STATE OF NORTH CAROLINA
DEPARTMENT OF TRANSPORTATION

May 1, 2020

Subject: Revised Modification Request for the Section 404 Individual Permit and Section 401 Water Quality Certification for the proposed Havelock Bypass in Craven County. TIP No. R-1015. Debit \$ 570 from WBS 34360.1.2

**PERMIT DRAWING
SHEET 17 OF 167**

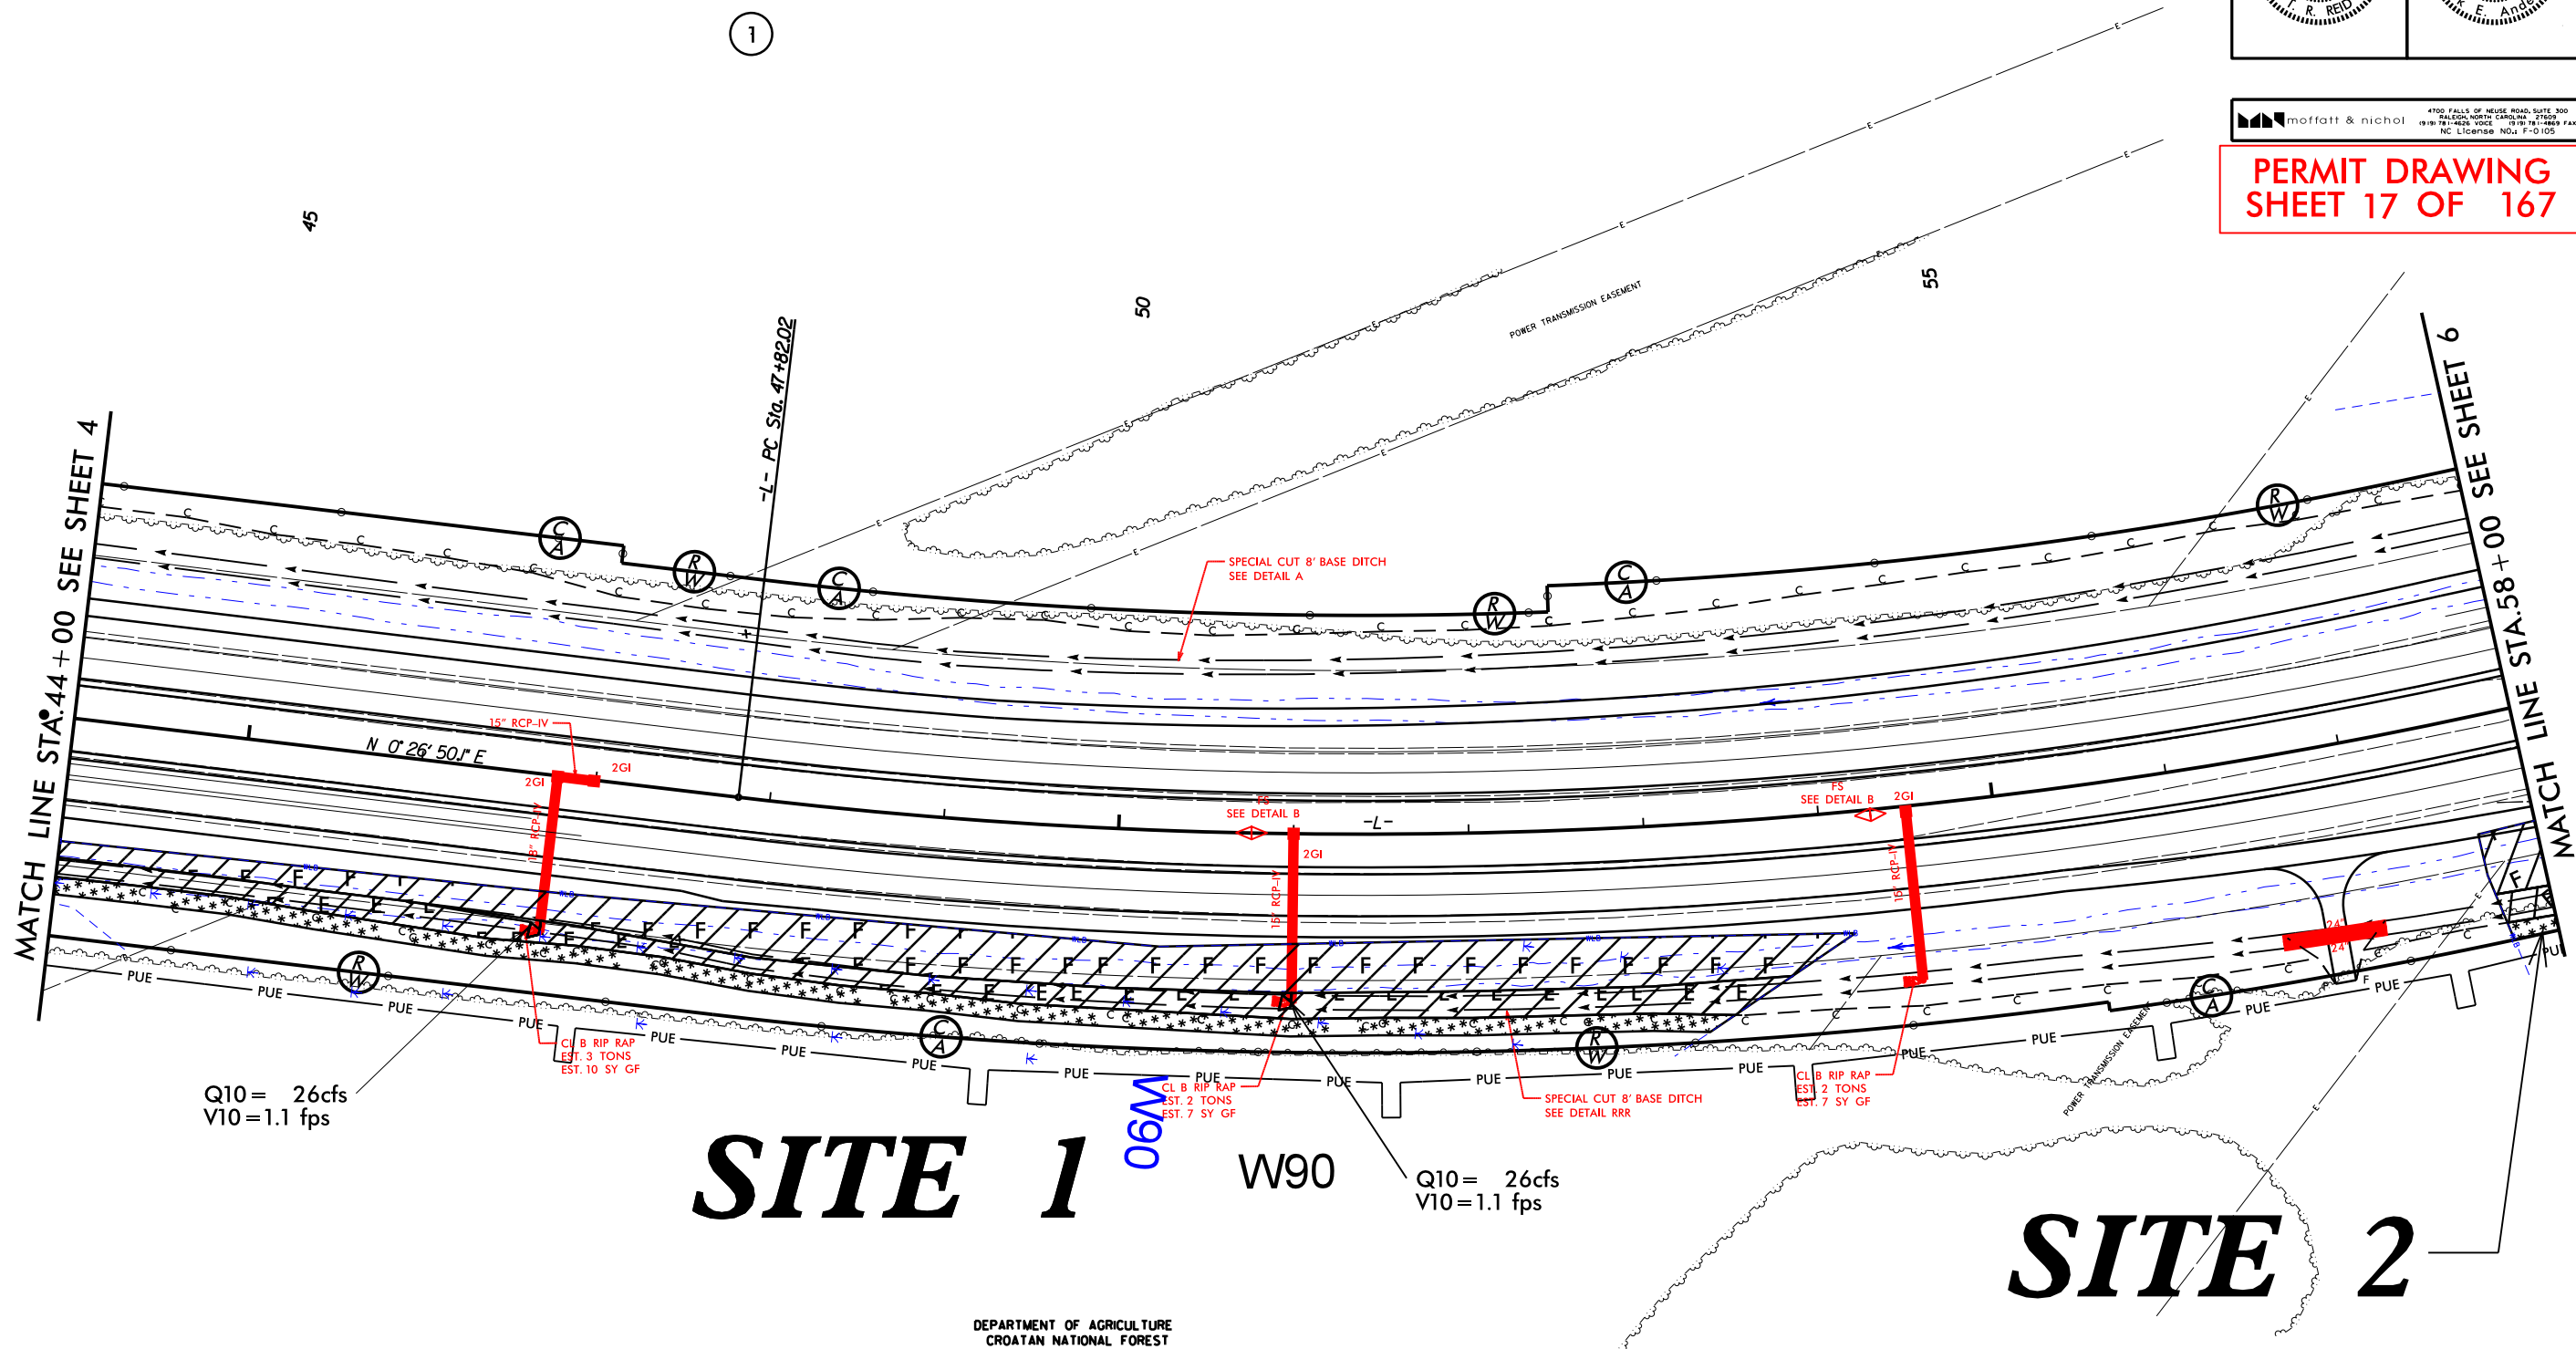
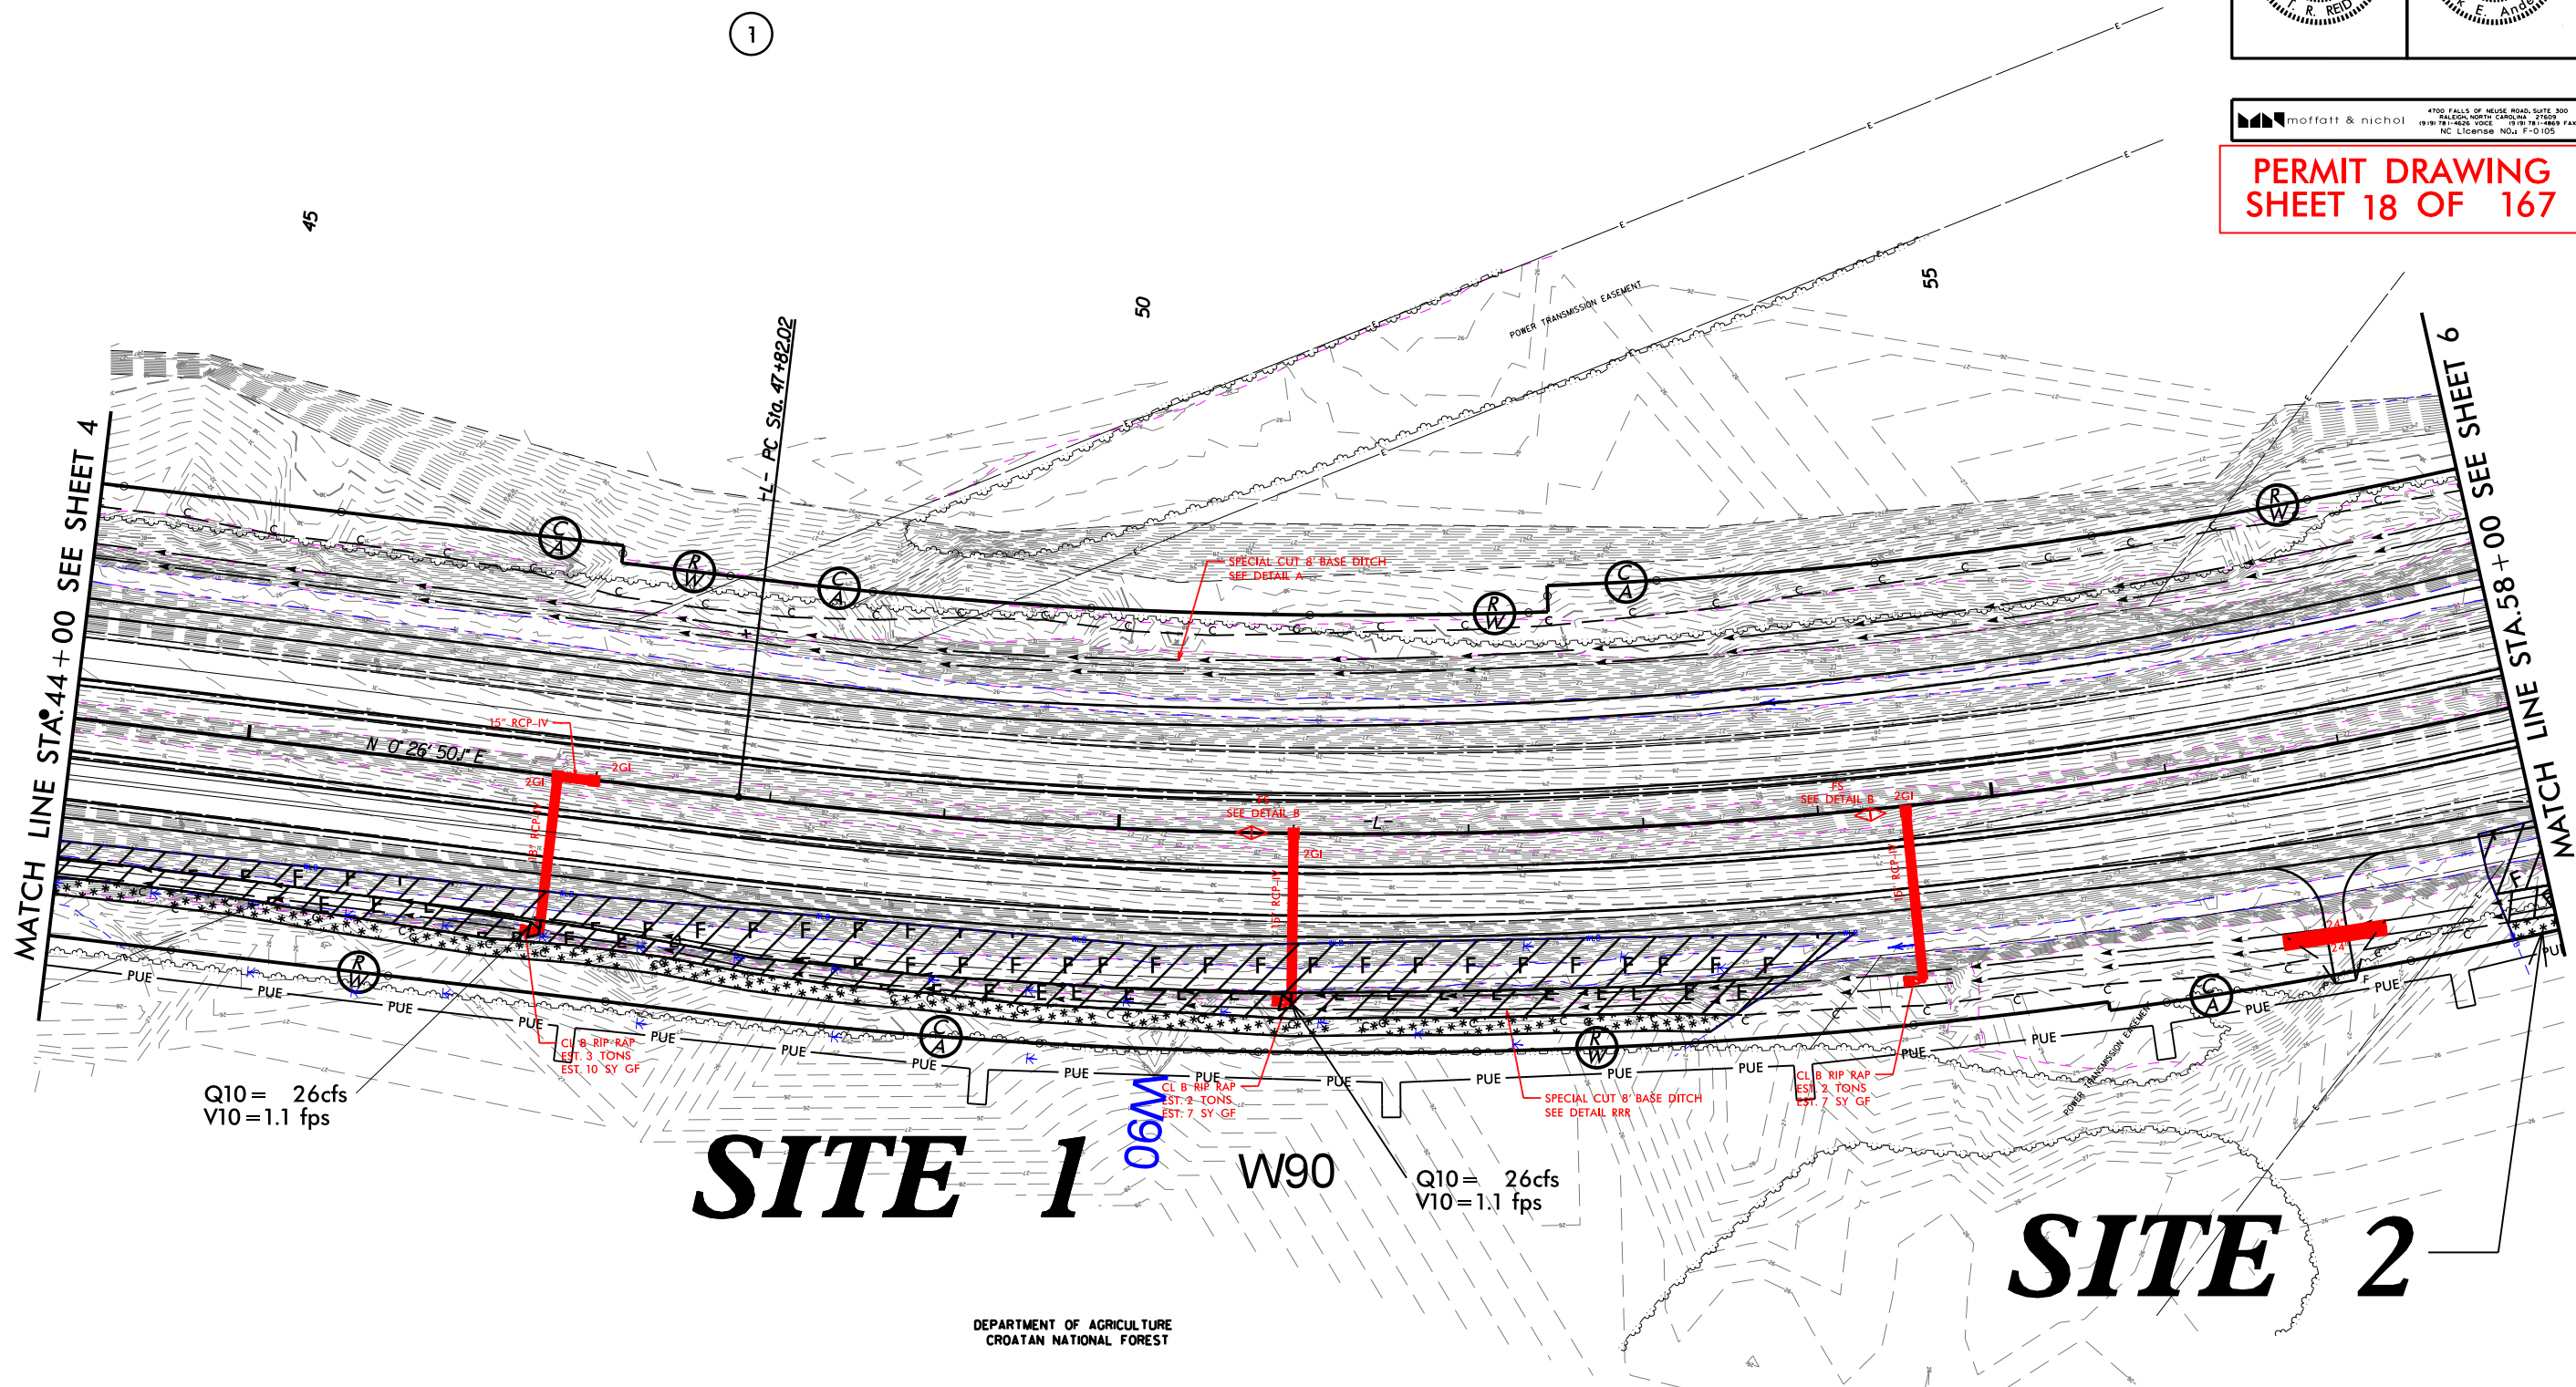
- Detail sheets updated (permit drawings 2 & 3)
- Site 1 (permit sheets 17&18) added riprap in the excavation area due to riprap pads at two pipes. A driveway was added, which did increase the impacts from fill, but decreased the mechanized clearing and excavation. The permitted total (1.16 acre) did not change.
